6.2 Containment Systems

The information in this section of the reference ABWR DCD, including all subsections, tables, and figures, as modified by the STP Nuclear Operating Company Application to Amend the Design Certification rule for the U.S. Advanced Boiling Water Reactor (ABWR), "ABWR STP Aircraft Impact Assessment (AIA) Amendment Revision 3," dated September 23, 2010 is incorporated by reference with the following departures and supplements.

Figure 6.2-3 Feedwater Line Break Flow—Feedwater System Side of Break

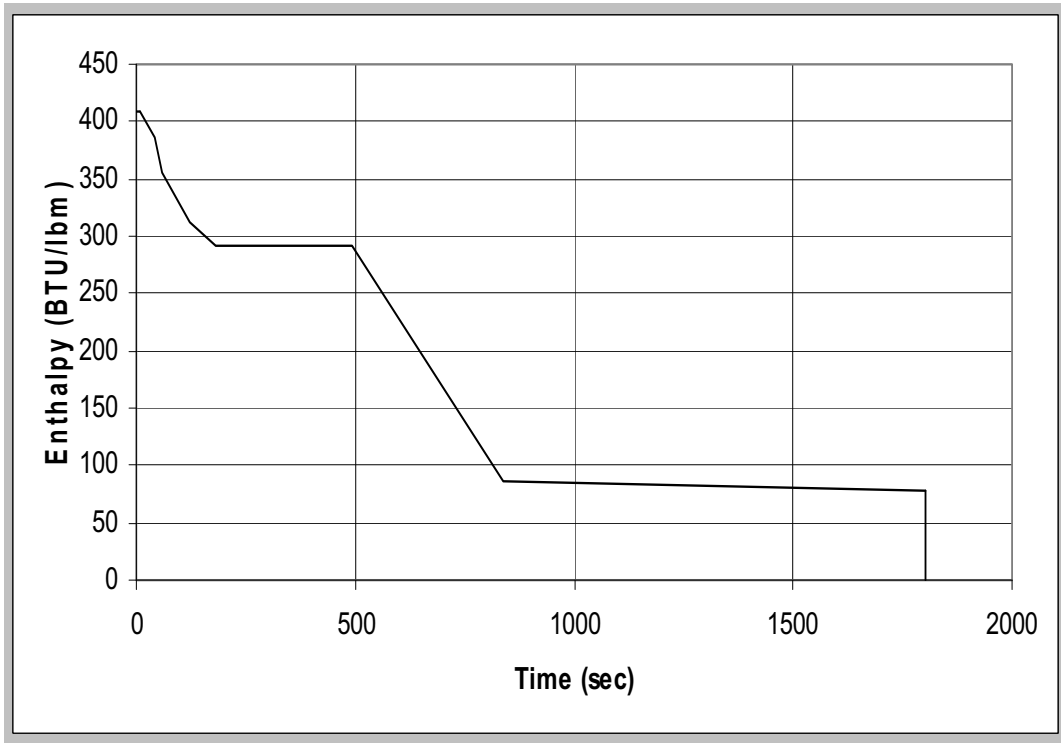
~~The maximum possible feedwater flow rate was calculated to be 164% of nuclear boiler rated (NBR), based on the response of the feedwater pumps to an instantaneous loss of discharge pressure. Since the Feedwater Control System will respond to decreasing RPV water level by demanding increased feedwater flow, and there is no FWLB sensor in the design, this maximum feedwater flow was conservatively assumed to continue for 120 seconds (Figure 6.2-3). This is very conservative because:~~

In order to provide further assurance of conservatism, FWLB mitigation is added to the ABWR design. The system is described in Section 7.3.1.1.2. The specific enthalpy time history, assuming the break flow of Figure 6.2-3, is shown in Figure 6.2-4. Initial reactor power is assumed to be 102% NBR.

Figure 6.2-6a Drywell Pressure Response for Feedwater Line Break

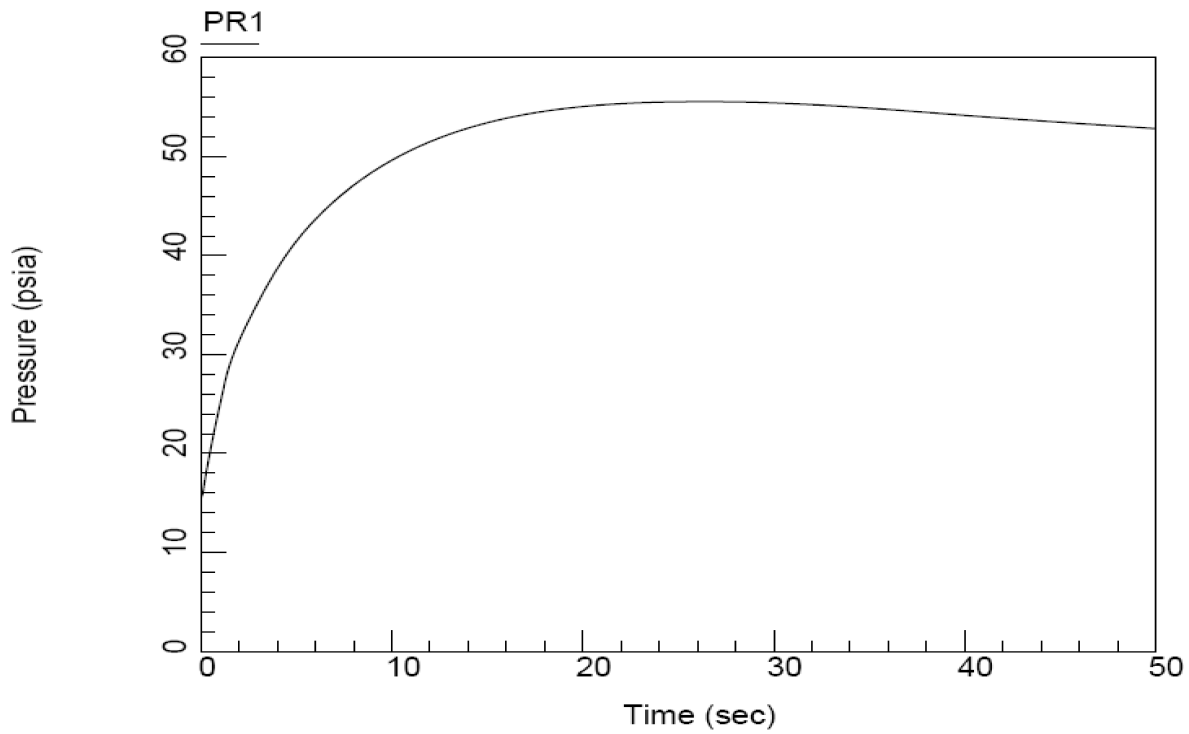
~~The calculated containment pressure and temperature responses for a feedwater line break are shown in Figures 6.2-6 and 6.2-7, respectively. The peak pressure (268.7 kPaG) and temperature (140°C) occur in the drywell. The containment design pressure of 309.9 kPaG is 115% of the peak pressure.~~

The short term pressure peak (268.7 kPaG) of Figure 6.2-6 is the peak pressure for the whole transient. Figure 6.2-8 shows temperature time histories for the suppression pool, wetwell, and drywell temperatures. The peak pool temperature (99.6°C) is reached at 6600 seconds (1.833 hours). This is less than the suppression pool temperature value of 100°C which is used in the net positive suction head available (NPSHA) calculations for RHR and HPCF.

The maximum drywell pressure occurs in the case of a feedwater line break (~~268.7~~281.8 kPaG). The design pressure for the drywell (309.9 kPaG) includes 16%approximately 10% margin.

Figure 6.2-9 ABWR Main Steamlines with a Break

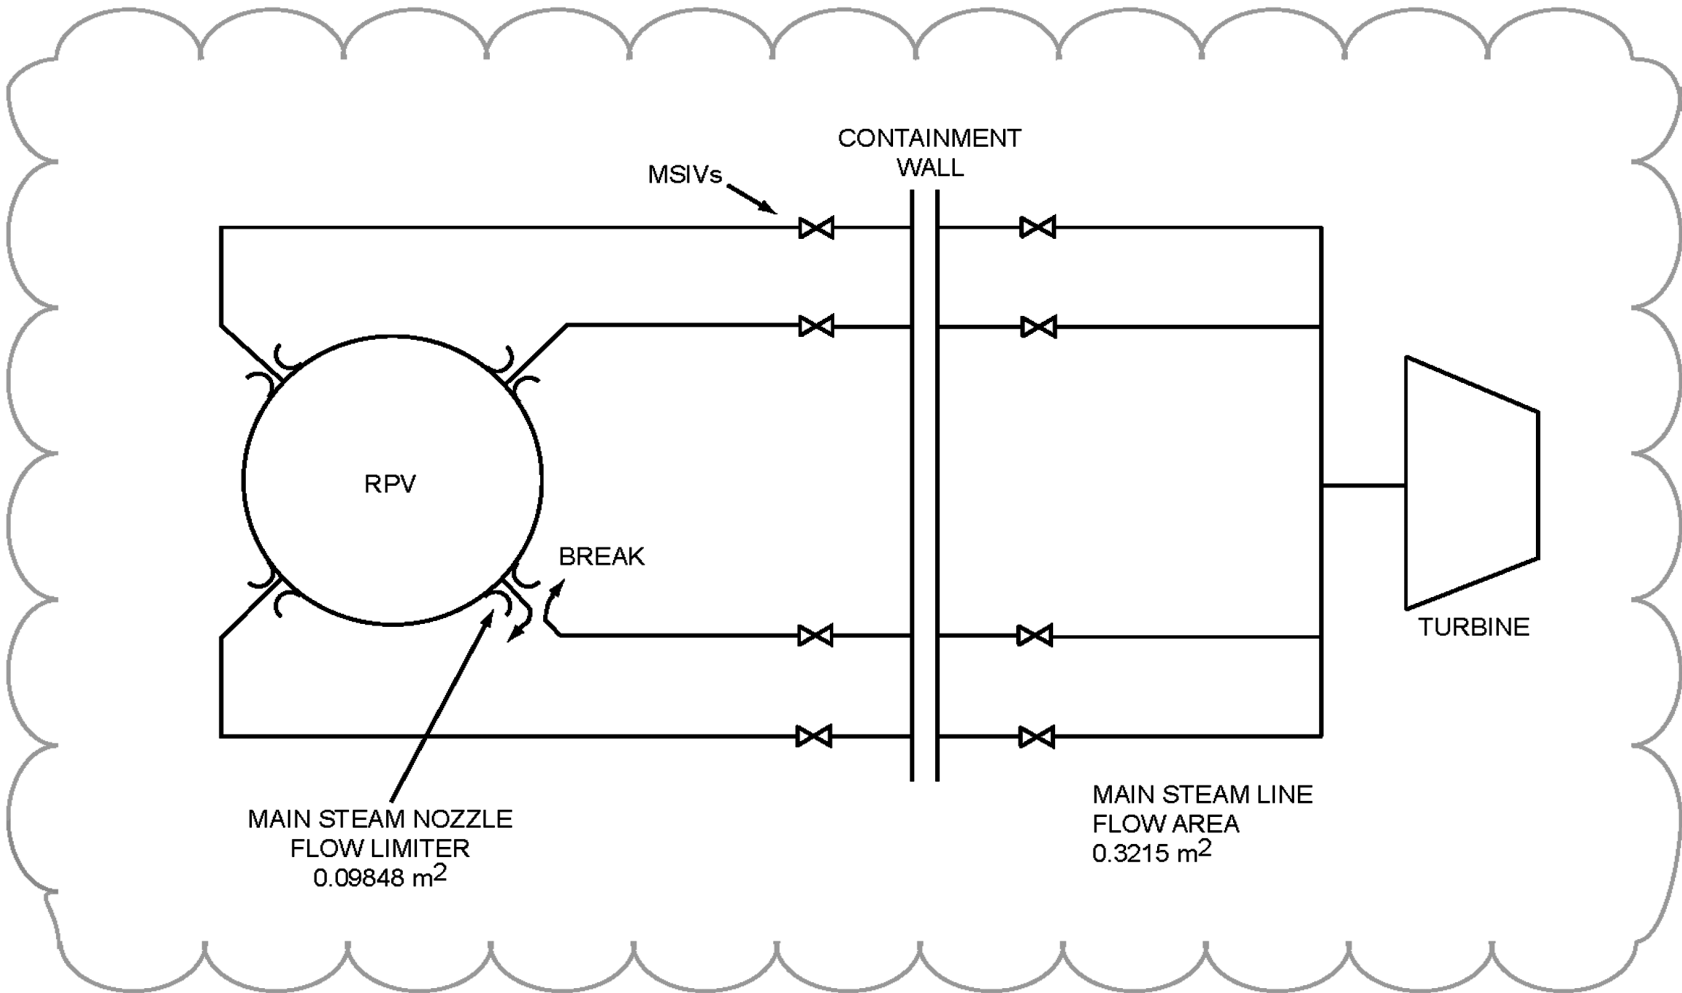
A schematic of the ABWR main steamlines, with a postulated break in one of the main steamlines, is shown in Figure 6.2-9. The main steamline (MSL) break is a double-ended break with one end fed by the RPV directly through the broken line, and the other fed by the RPV through the unbroken main steamlines until the MSIVs are closed. Once the MSIVs are closed, the break flow is only from the RPV through the broken line.

Each MSL contains a flow limiter built into the MSL nozzle on the RPV with a throat area of 0.09848 m², as shown in Figure 6.2-9. This flow limiter provides the effective break area for the vessel side.

- (1) Each MSL contains a flow limiter built into the MSL nozzle on the RPV with a throat area of 0.0983m², as shown in Figure 6.2-9.*
- (2) The break is located in one MSL at the inboard MSIV.*
- (3) During the inventory depletion period, the flow multiplier of 0.75 is applied (Reference 6.2-1).*
- (4) The flow resistance of open MSIVs is considered. A conservative value of 2.062 for pressure loss coefficient for two open MSIVs was taken. The nominal value is approximately 3.0. When the open MSIV resistance is considered, the flow chokes at the MSIV on the piping side as soon as the inventory depletion period ends. The effective flow area on the piping side reduces to 70% of a frictionless piping area. The value of 70% applies to flow of steam and twophase mixture with greater than 15% quality.*

Figure 6.2-12a Drywell Pressure Time History for MSLB

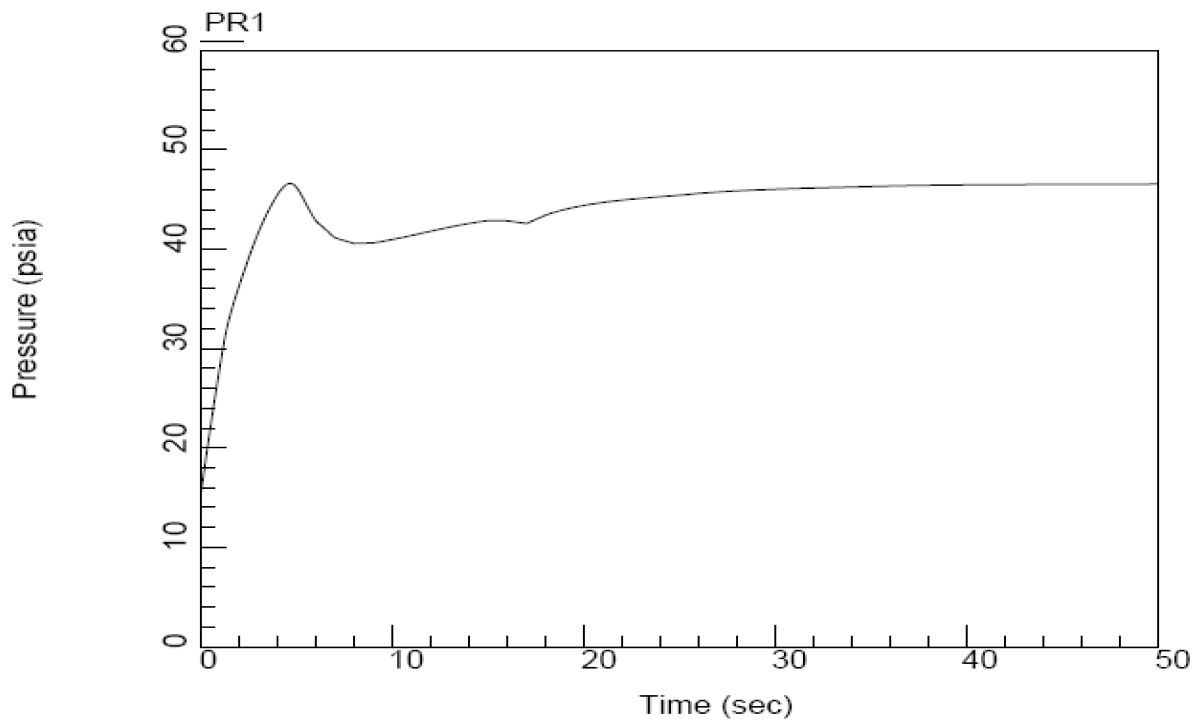
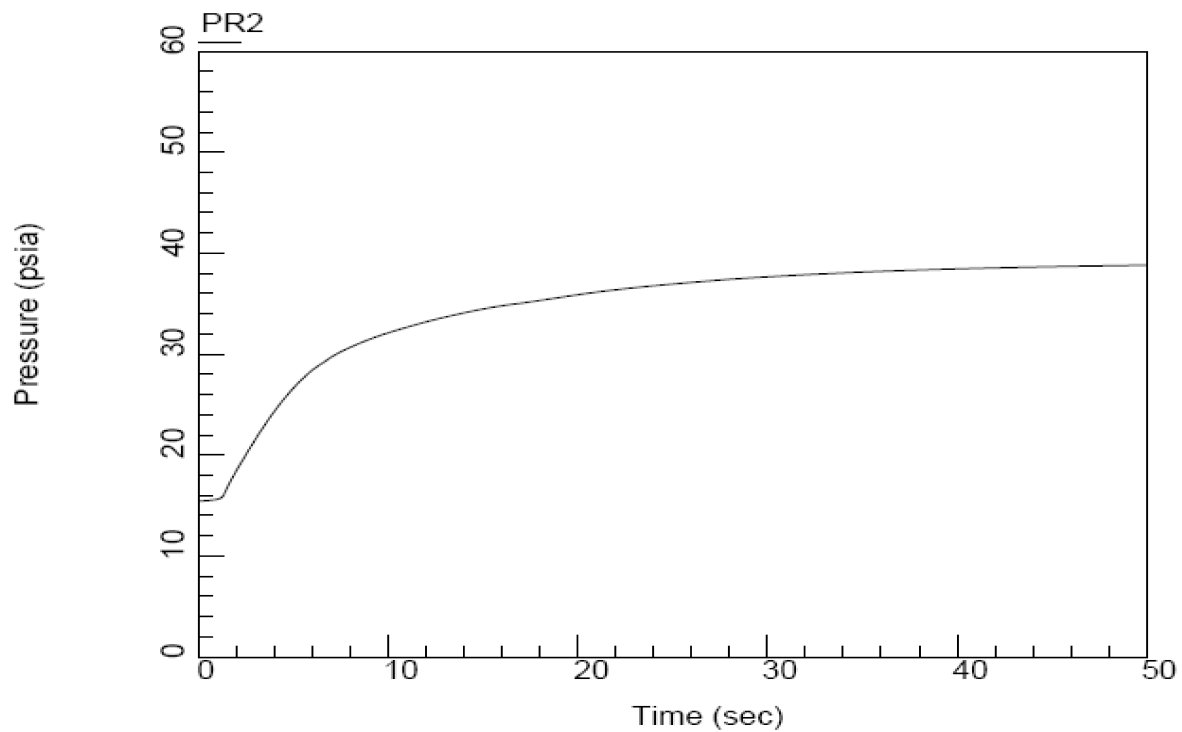
Figures 6.2-12 through 6.2-15 and 6.2-13 show the pressure and temperature responses of the drywell and wetwell during the blowdown phase of the steamline break accident.

Figure 6.2-13a Drywell Temperature Time History for MSLB

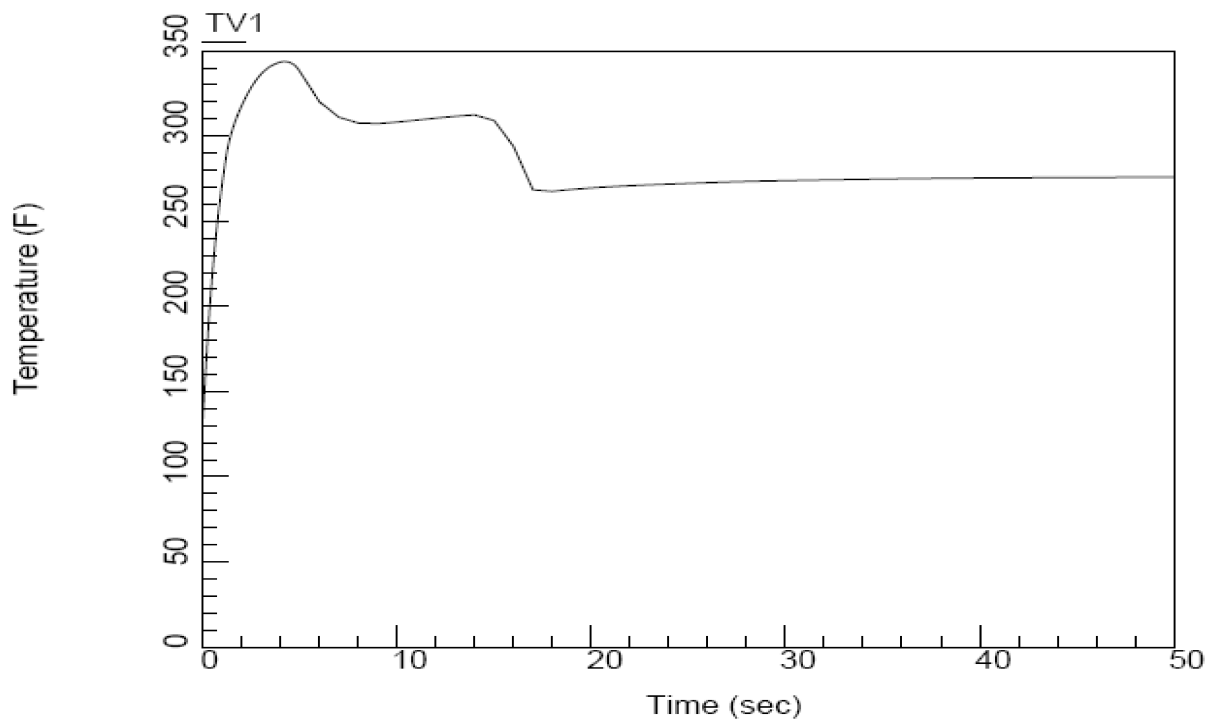
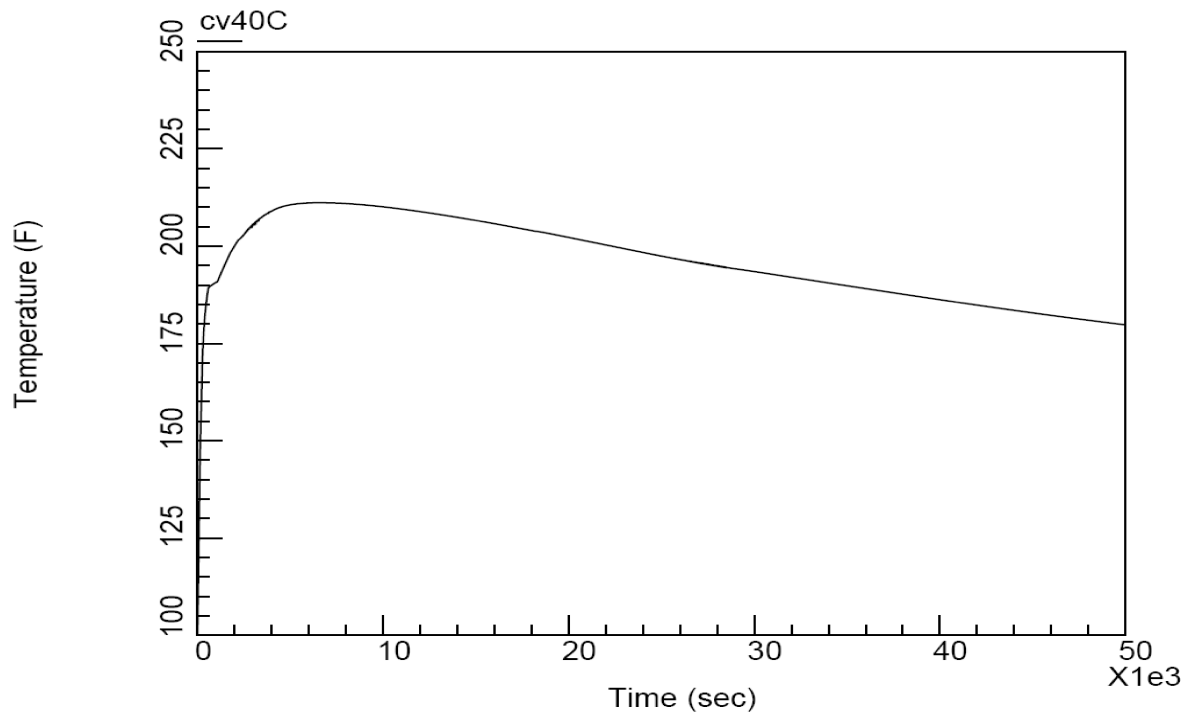
The long term containment pressure and temperature responses following the MSLB accident remain below those for the feedwater line break, which is the most limiting event. The long-term containment pressure response following the MSLB accident remains below that for the feedwater line break. The long-term temperature response remains below that for the peak achieved in the short term for the steam line break shown in Figure 6.2-13.

The maximum drywell temperature occurs in the case of a steamline break (~~169.7°C~~173.2°C). Although this exceeds the ABWR drywell design temperature (171.1°C), it only exceeds it by 2.1°C and only for about 2 seconds. Due to thermal inertia, components in the drywell would not have sufficient time to reach the design limit temperature, and is below the design value (171.1°C).

The maximum drywell temperature (173.2°C) is predicted to occur for the steamline break. The MSLB with two-phase blowdown starting when the RPV collapsed water level is at or below the main steamline nozzle provides the highest peak drywell temperature. The peak drywell air temperature is 169.7/173.2°C, below the which is above the design value of 171.1°C, and is the limiting one as compared to the FWLB peak temperature. As noted in Section 6.2.1.1.2.1, this peak calculated drywell temperature exceeds the design limit for only 2 seconds. The peak drywell pressure for the MSLB remains below that for the FWLB, which becomes the most limiting. The peak drywell pressure is below the design pressure. The MSLB is the limiting event for peak drywell temperature. The FWLB is the most limiting for drywell pressure.
